CARVER FALLS HYDROELECTRIC PROJECT
FERC Project No. 11475

RECREATION PLAN

Central Vermont Public Service Corp.
77 Grove St.
Rutland, VT 05701

February 2010

SHEET TITLE:
DIAGRAMMATIC SITE PLAN

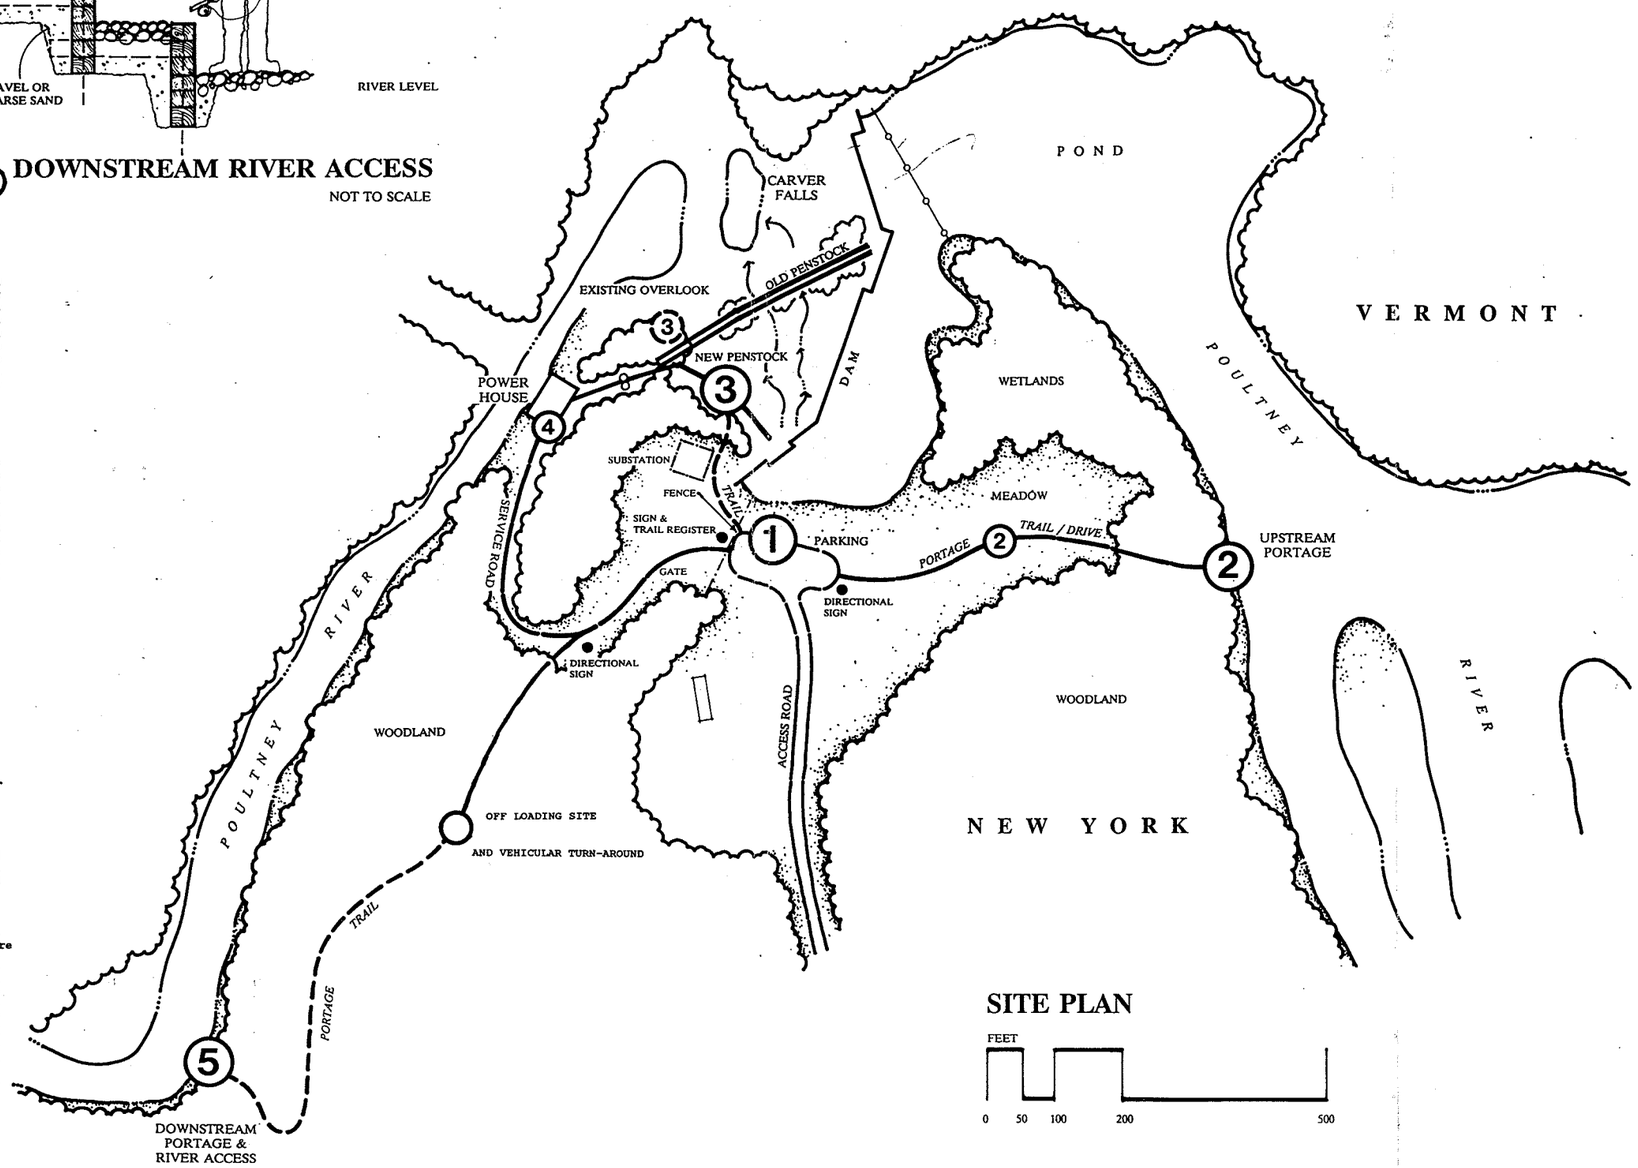
1 ■ PARKING AREA
Since the parking area appears to provide sufficient parking to meet the recreational demand at this time there is no need to enlarge or formally surface the area beyond its existing size and condition. It is recommended that some of the existing vegetation that obscures views of the pond and dam be removed to open views of the pond and dam as seen from the road and parking area. Signage should be incorporated to inform the viewer of the significance and history of the site and direct the visitor and recreationist to points described below. A site register should be located at the parking area to gather information regarding the amount and types of use.

2 ■ MEADOW, UPPER PORTAGE AND POND ACCESS
A canoe portage trail should be established that begins on the upstream side at a point across the meadow and upstream of the wetland area. The beginning of the trail is located at grade with the pond's edge and in an area where disturbance can be kept to a minimum. Launching and removing canoes from the pond at this site is relatively easy and does not bring the canoeist within the warning buoys and potential hazard presented by the dam. Driving access should be provided to this upstream portage site. A narrow drive currently exists across the meadow and may have to be slightly improved to reach the portage site. Signage should be provided to direct the canoeist to the landing and portage.

3 ■ VIEWING AREAS OF THE FALLS
The current platform located on the active penstock should be improved to be more visible and accessible. This will require that directional signage be incorporated leading the viewer from the parking area to the viewing area and that the platform be widened and railings provided. Interpretive signage should be provided that describes the natural features and history of the hydroelectric use. The other viewing area located on the precipitous point should be discouraged from use. Utilization of this location and trails down to the falls will continue no matter how the site is signed, however, use of more hazardous areas should be discouraged for safety reasons and to prevent environmental degradation of the resource. No changes should be made that compromise the view of the falls, dam amd old penstock. All of these features contribute to the significance of the scene and should remain intact. By no means should the old penstock be removed.

4 ■ POWER HOUSE
Signage should be placed on the power house indicating its age and function. Driving access should not be provided to the general public. Walking access should be encouraged and signed along the access road and trail leading down from the substation.

5 ■ TRAIL TO LOWER PORTAGE AND RIVER ACCESS
The trail to the lower portage will be improved to accommodate vehicular traffic to a point just before the trail starts to descend. At this point an off-loading site and vehicle turn-around shall be constructed. Recreationists will be able to unload and return their vehicle to the parking lot. The trail to the lower portage and river access should be well signed from the upper portage site and from the parking area. Trail drainage should be improved by diverting storm water that currently funnels onto the trail and by constructing water bars for cross drainage at regular intervals. A series of wood crib terraces backfilled with gravel and cobbles should be constructed at the river bank to provide easier movement up and down to the water's edge. The terraces or steps can be approximately 24" in height with a tread width of 24-36". The overall width of the access should be determined by the configuration of the river bank. The terraces can be carved out of the existing embankment and recessed into the bank preventing them from being exposed during high water. Construction of the access steps/terraces will provide easier movement into the river for canoeists and fisherman, while preventing erosion of the river bank where the path currently leads to the river's edge.

CARVER FALLS
PROPOSED LOOKOUT

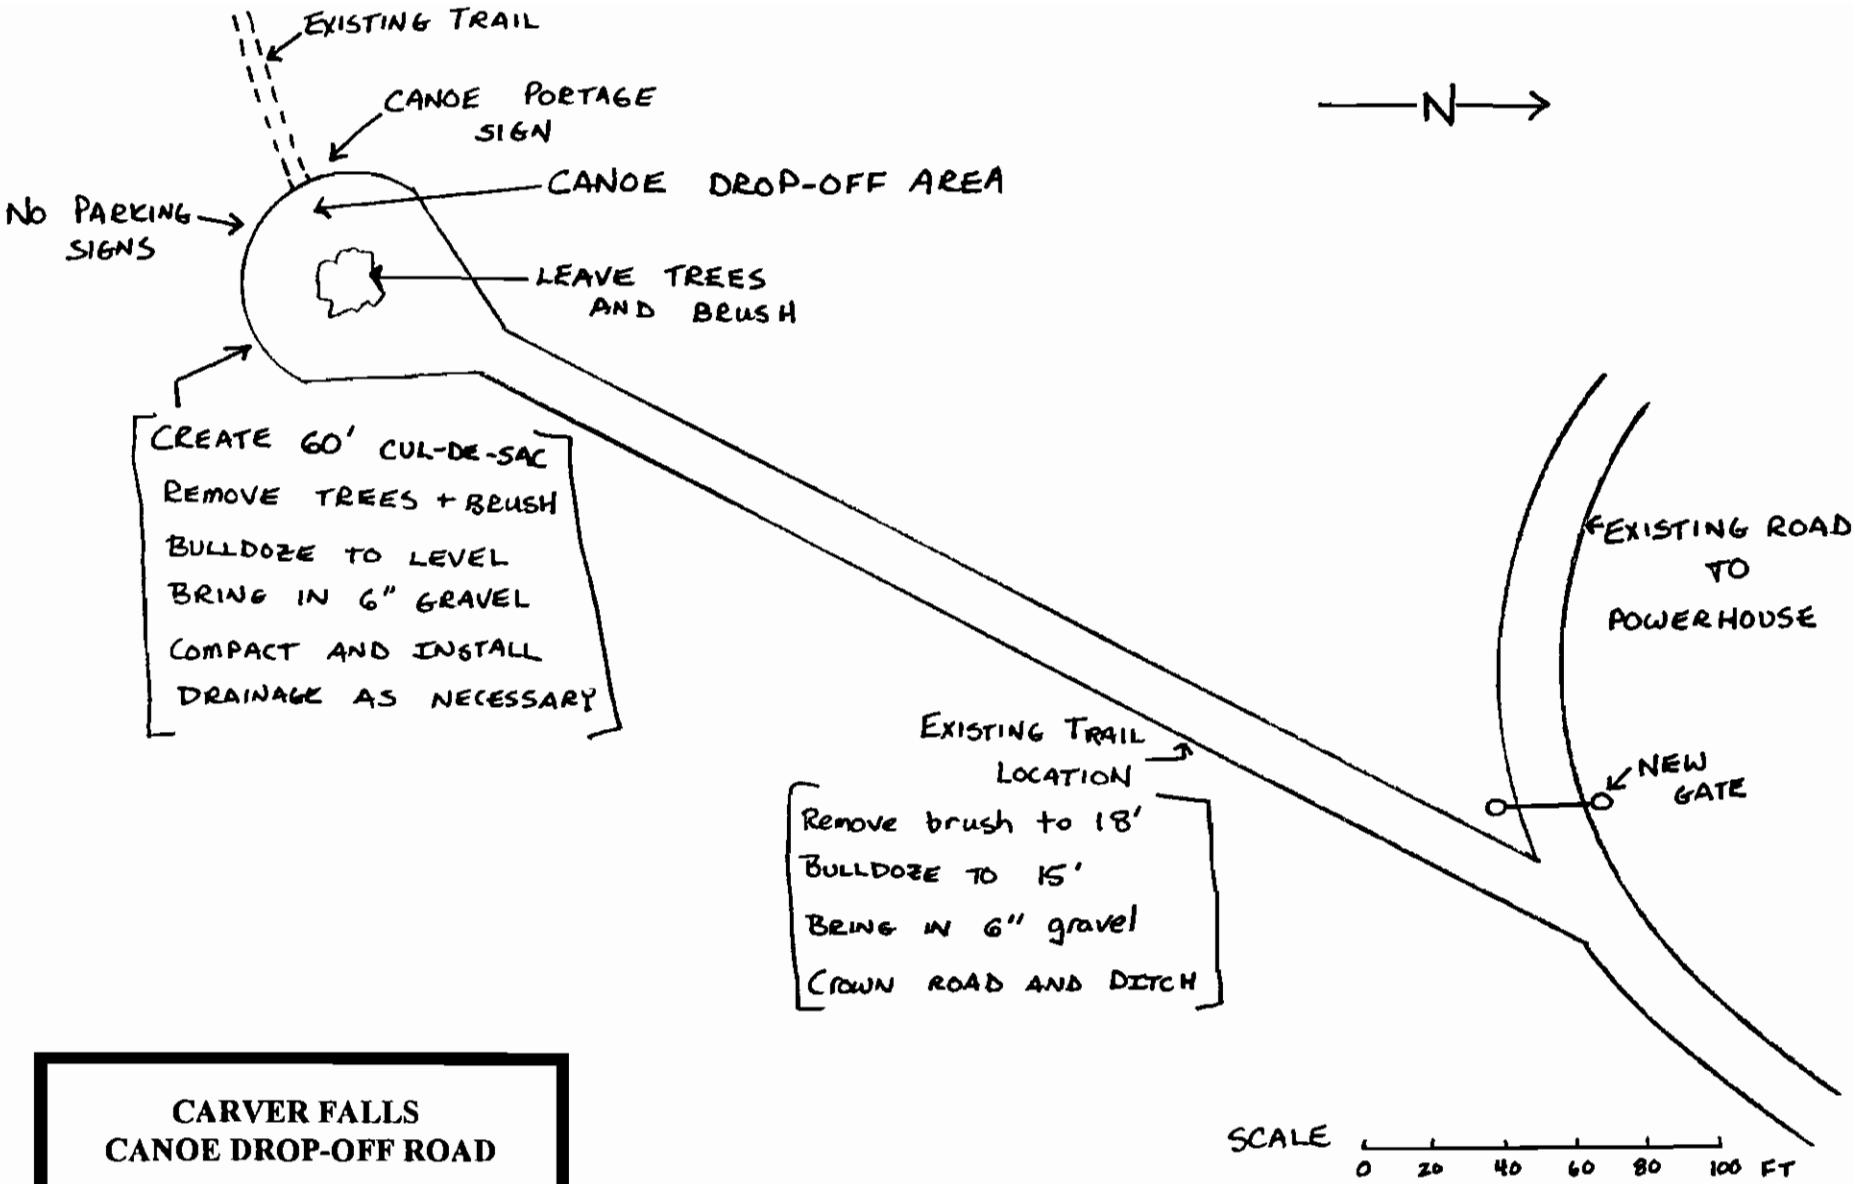
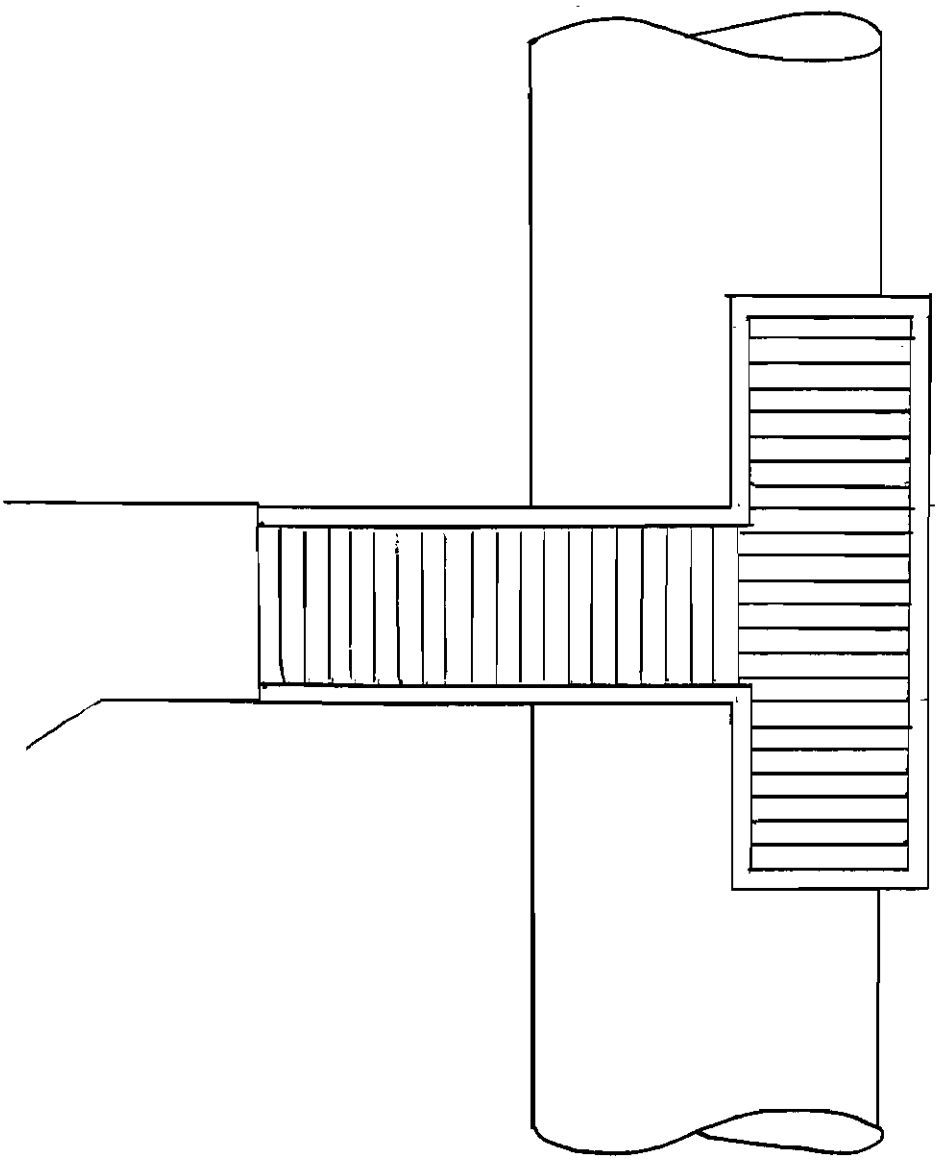
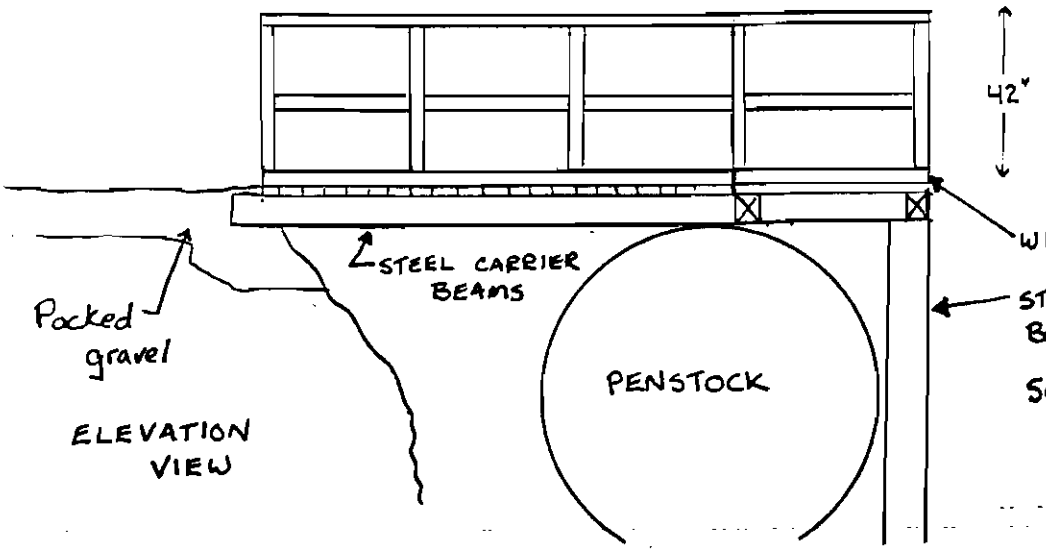
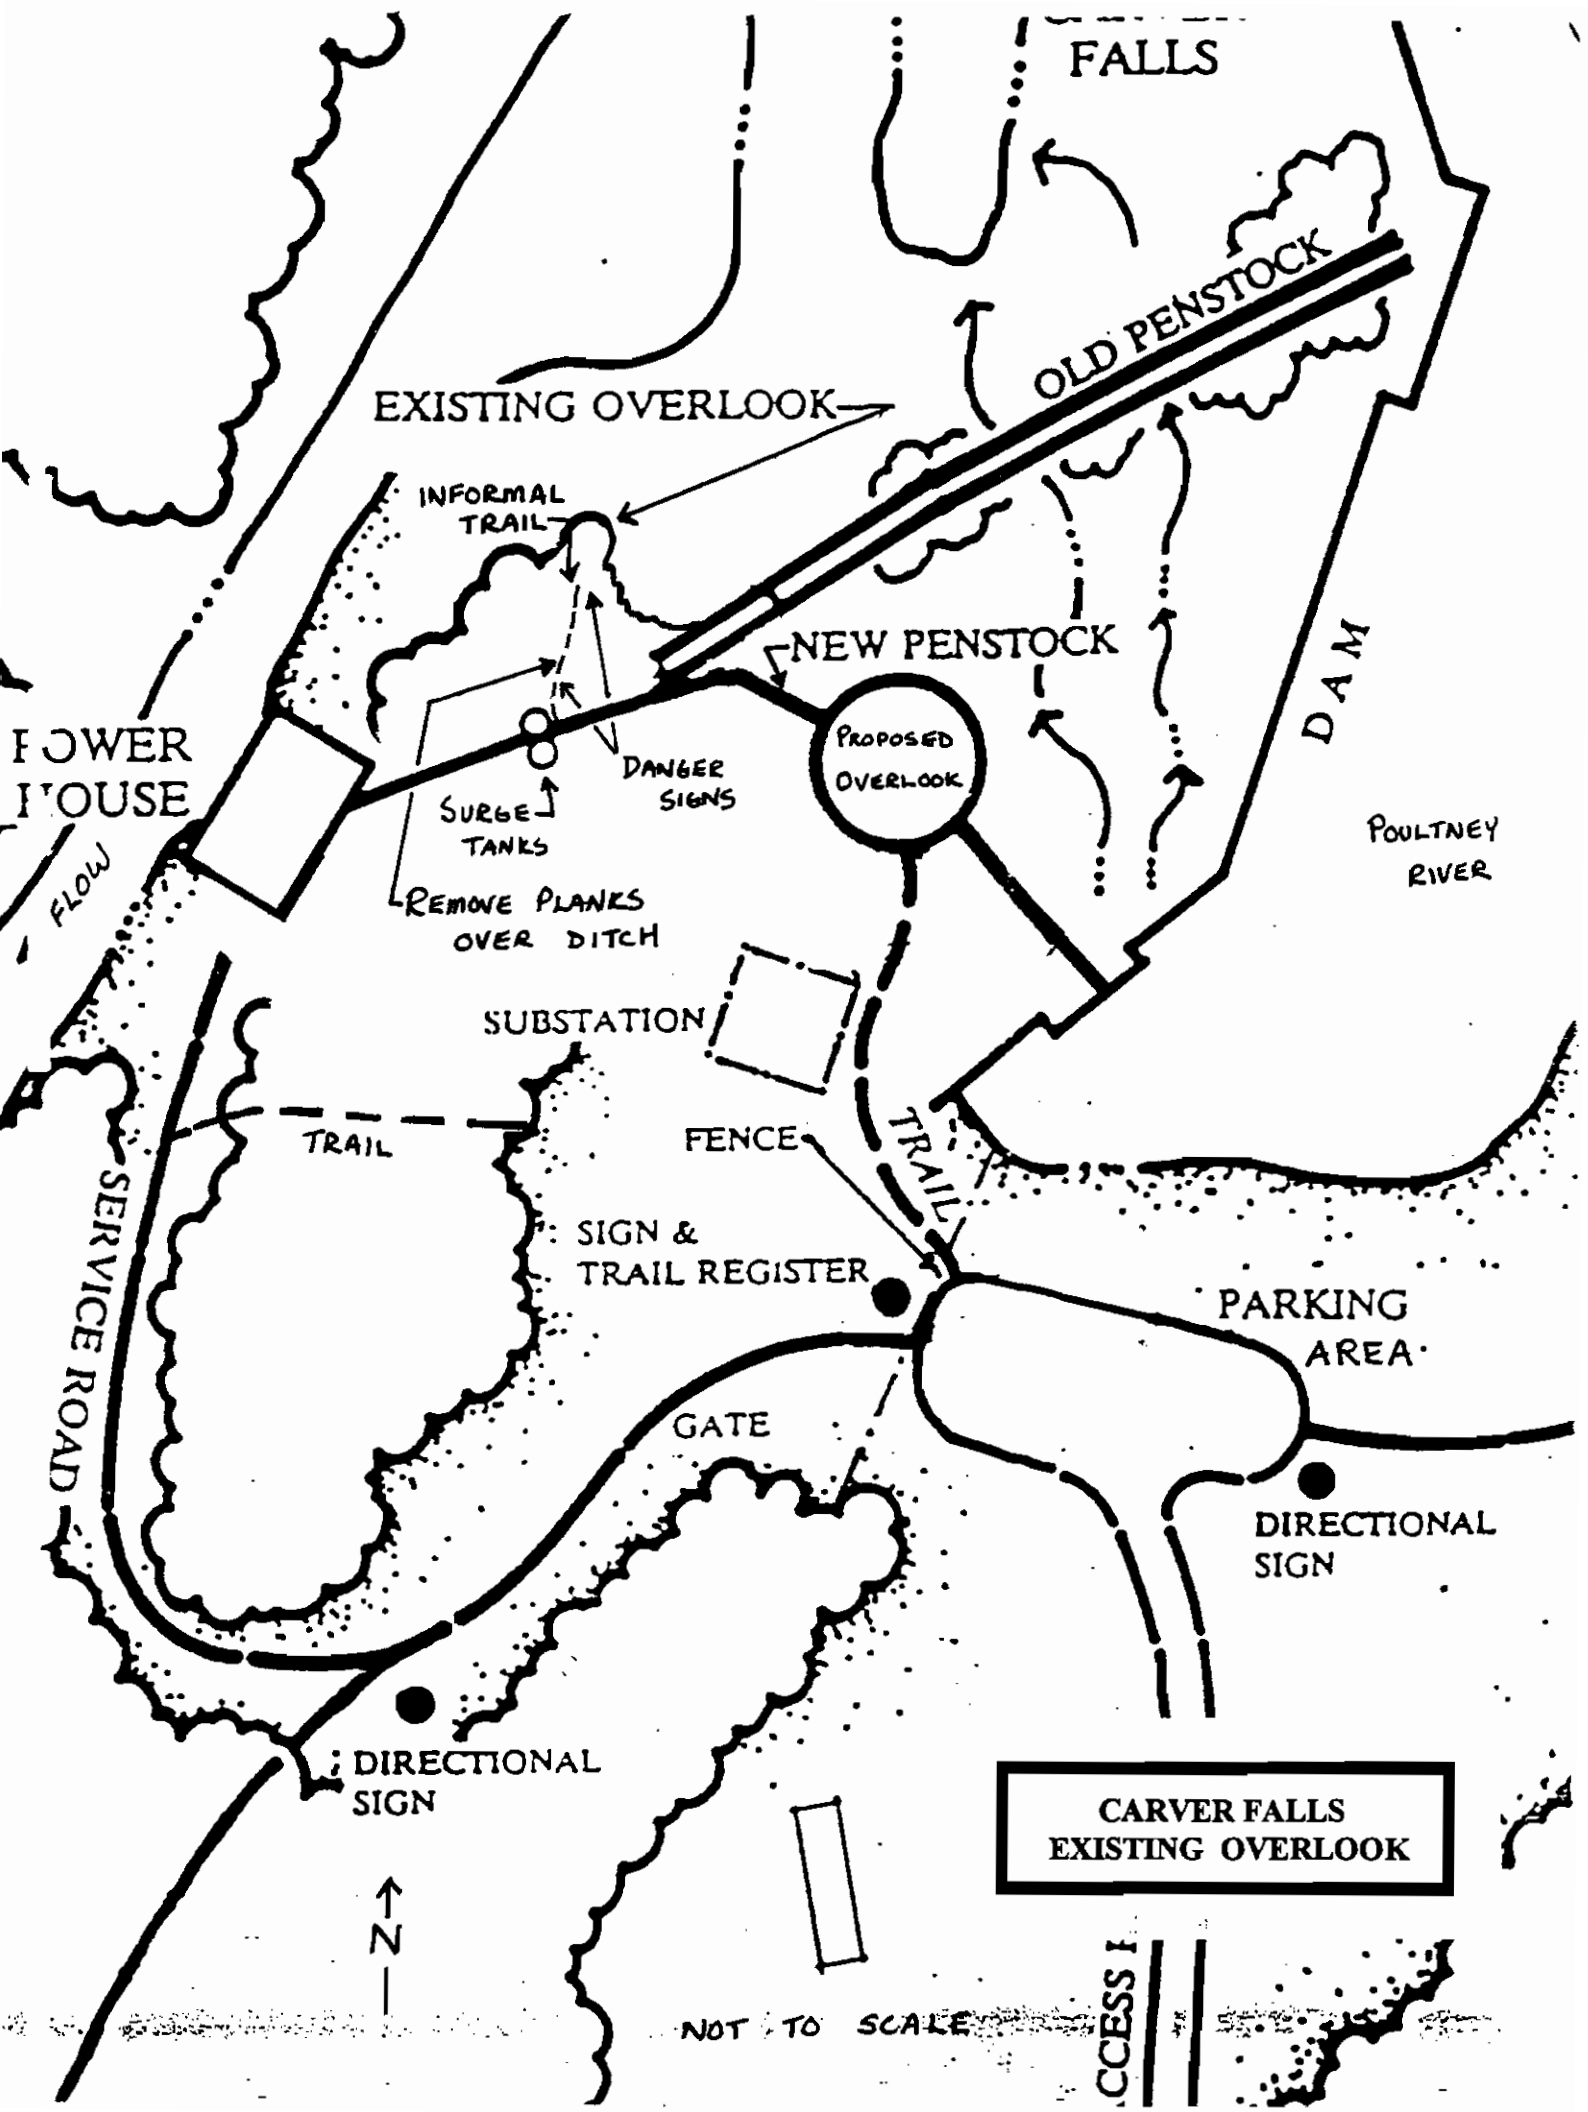
CVPS initially proposed enhancements to the existing overlook on top of the active penstock to include: (1) a new 4-foot-wide, pressure treated, pine deck; (2) a 42-inch-high safety railing; (3) replacement of the steel carrier beams anchoring the deck; (4) placement of gravel on the penstock trail; (5) improvements to interpretive signage and (6) removal of vegetation obstructing views. VANR (by letter dated February 14, 1996) stated that the trail to the penstock lookout should be packed limestone so that it is accessible to persons in wheelchairs. The 1996 AIR provided a conceptual design drawing of the proposed penstock overlook.

CVPS and its landscape architect visited the site in April 2009 to begin developing designs for the recreation improvements. During that site visit, the grade was measured along the proposed access trail from the parking area down to the existing penstock overlook location and it was determined that the grade was too steep to allow for safe wheelchair access in accordance with the Americans with Disabilities Act of 1990. Therefore, CVPS is proposing an alternative viewing location closer to the dam. The alternate design will include an improved path leading to a viewing area closer to the dam, interpretive signage and removal of vegetation obstructing views. The existing penstock overlook platform will be removed due to safety concerns.
